NOAA FORM 76-35A	
U.S. DEPARTMENT OF COMMERCE NATIONAL OCEANIC AND ATMOSPHERIC ADMINISTRATION NATIONAL OCEAN SURVEY	
DESCRIPTIVE REPORT (HYDROGRAPHIC)	
Type of Survey .....	Hydrographic
Field No. ....	FA-5-3-77 (1978) Addendum
Office No. ....	H-9672a
LOCALITY	
State .....	California
General Locality .....	Long Beach Harbor
Locality .....	Queensway Bay
.....	
<u>1978</u>	
CHIEF OF PARTY Bruce I. Williams	
LIBRARY & ARCHIVES	
DATE .....	May 11, 1979

ADDENDUM TO DESCRIPTIVE REPORT  
FOR  
HYDROGRAPHIC SURVEY H-9672a  
(FIELD NO. FA-5-3-77)  
NOAA SHIP FAIRWEATHER S220

SUBJECT: Quality Control Report for H-9672a (1978), California, Long Beach Harbor, Queensway Bay

9. Reference the hydrographer's comments pertaining to investigation item 22 on page 5 of the Descriptive Report:

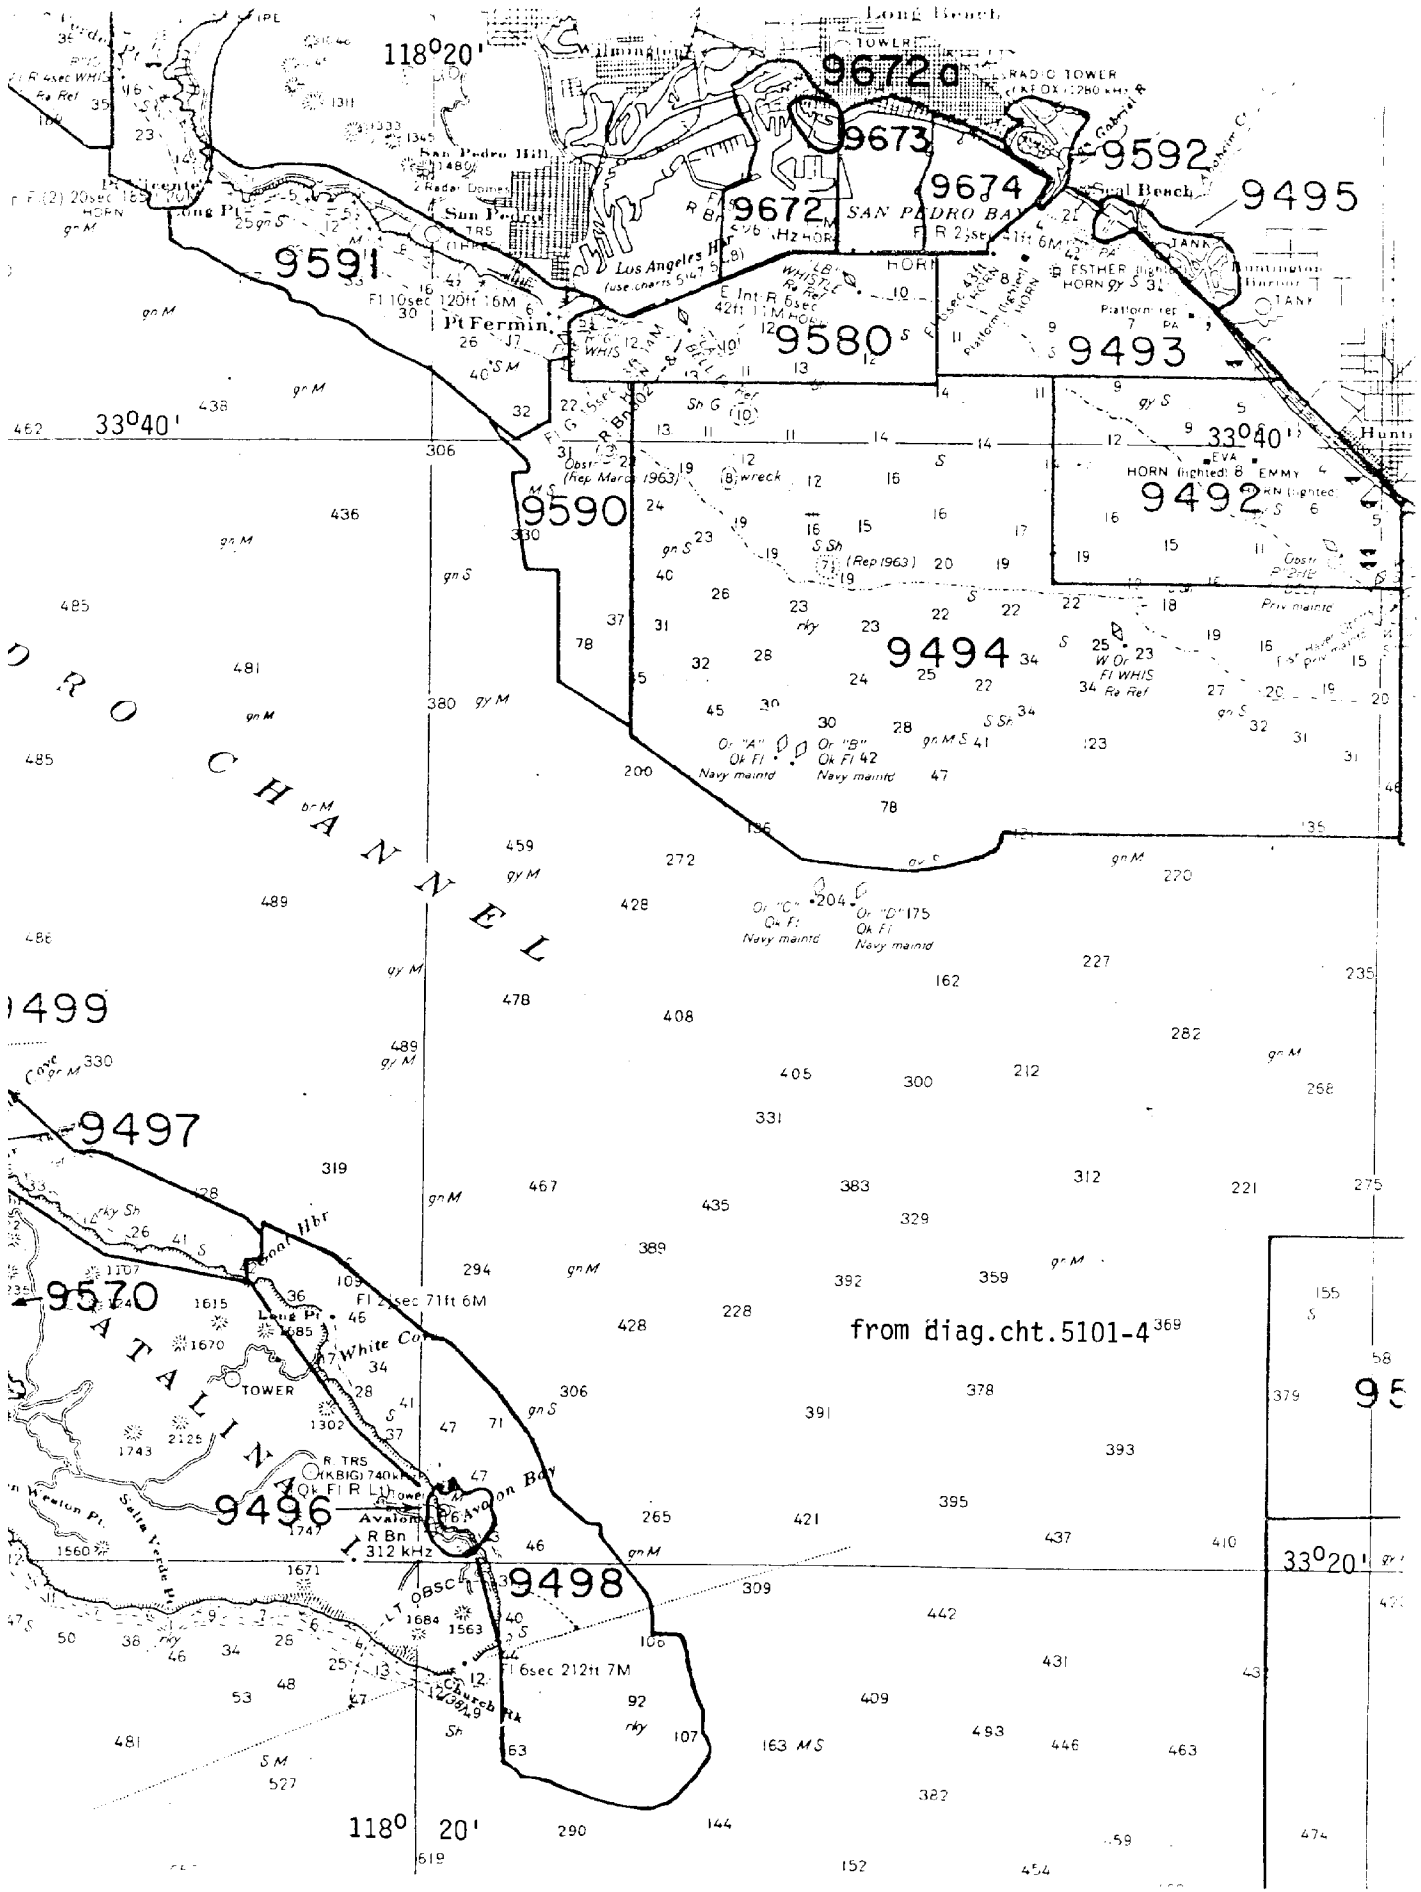
Since a least depth is mentioned, it should have been appropriately corrected and included in the Descriptive Report to facilitate its application to the chart. The actual magnitude of the referenced depth was not indicated by either the hydrographer or the verifier. The Descriptive Report was appropriately annotated during quality control inspection.
